**ADVISORY BOARD ON
RADIATION AND WORKER HEALTH**
National Institute for Occupational Safety and Health

***Review of the Rocky Flats Plant Special Exposure Cohort (SEC) Petition,
SEC-00030***

Volume 1: Main Report

**Contract No. 200-2004-03805
Task Order No. 5
SCA-SEC-TASK5-0052**

Figure 6-1. Predicted Plutonium Bioassay Results (line) Calculated Using IMBA-derived Pu Intake Rates Compared with Measured Pu-in-Urine Results (dots)

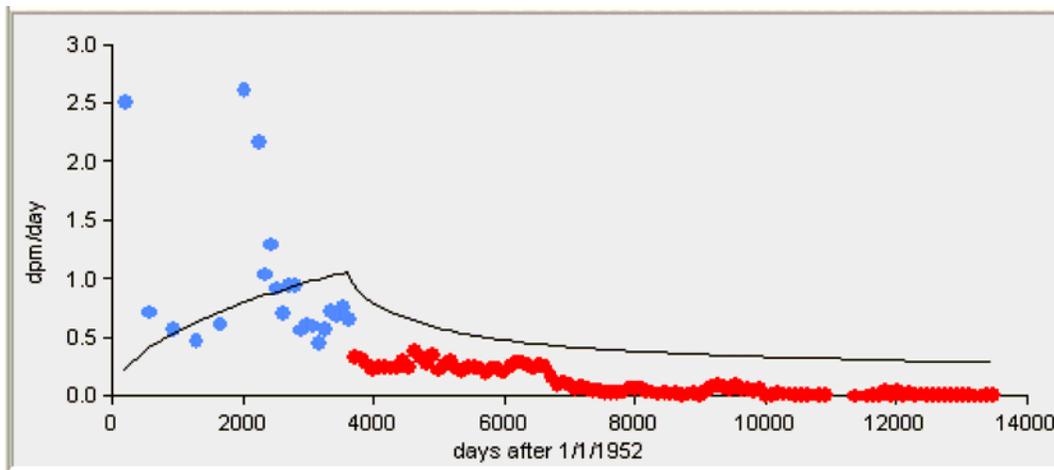
In conclusion, SC&A considers the lognormal distribution used by NIOSH in these applications not to be representative of the higher bioassay values. Essentially, the recorded high-end dose values are left out. Therefore, the uncertainties derived from the lognormal distribution are misleading since they do not adequately address the contribution of these higher internal dose results. In addition the value of the 50th percentile is an artificial number, not related to any measured value, and thus it is not to representative of the monitored worker excretion rate.

Approach 2: The intake model was derived using an IMBA fit to several years of data. Intakes were not derived for each time period, when a GM would have been derived from the lognormal distribution representing that time period. Instead, an IMBA fit was derived for a period of several consecutive years. For Type M plutonium, for example, just one intake rate was considered for the period from 1952 to 1961. This intake rate theoretically produces excretion rates for 1952 to 1961, which can be represented by the solid line shown in the Figure 6.1, comparing the theoretical fit for Type M materials to the individual 50th percentile excretion rates (Arno et al. 2006). As can be observed, there are large discrepancies between the predicted bioassay results using the derived intake rates for the period (solid line) and the GM results for the different periods (blue dots). The red dots correspond to time periods after 1961.

Figure 8-1. Proportion of Workers Monitored for External Dose at Rocky Flats
Source: Langsted 2006

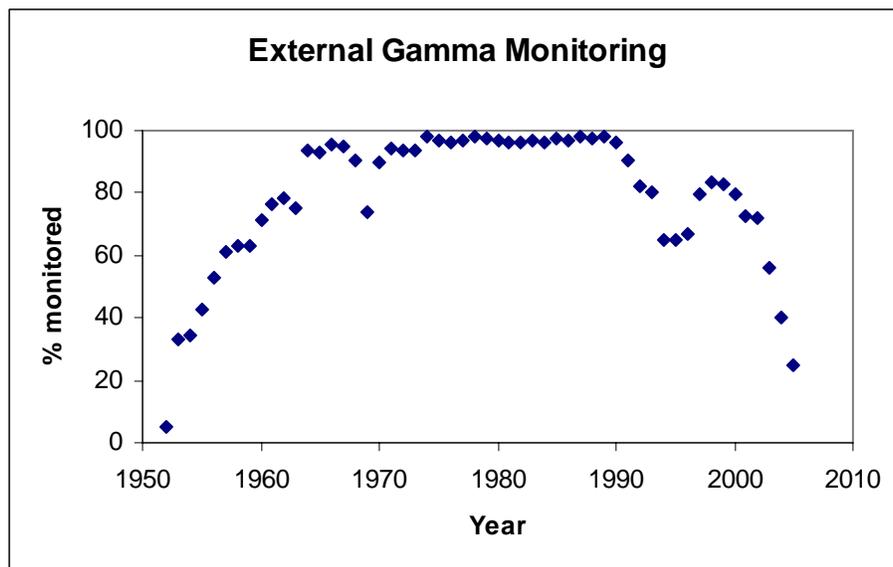
The data in Table 8.1 and Figure 8.1 should be treated with some caution since they are based on a sample whose representativeness has not been established. Specifically, the percentages are derived from a review of 1,046 Rocky Flats claimant files (Langsted 2006). While this is a large sample, the representativeness of claimants to the entire Rocky Flats workforce, including subcontractors, covered by the proposed SEC class has not been established and no method to do so is evident. Specifically, the job types and periods represented by the claimant file sample may not correspond to the proportions in the worker population. Some job types may not be represented. The practical consequences of this issue are discussed later in this chapter.

Notably, the year 1969 shows a sharp drop in proportion badged. This appears to be the result of equating the gaps in the external dosimetry record as nonmonitoring. Strictly speaking, many badges that were issued were not read, even though they were issued. (See analysis of the 1969 data in Section 4.3.1.) SC&A concurs that unread badges should be treated as if the employee were not monitored in that period.
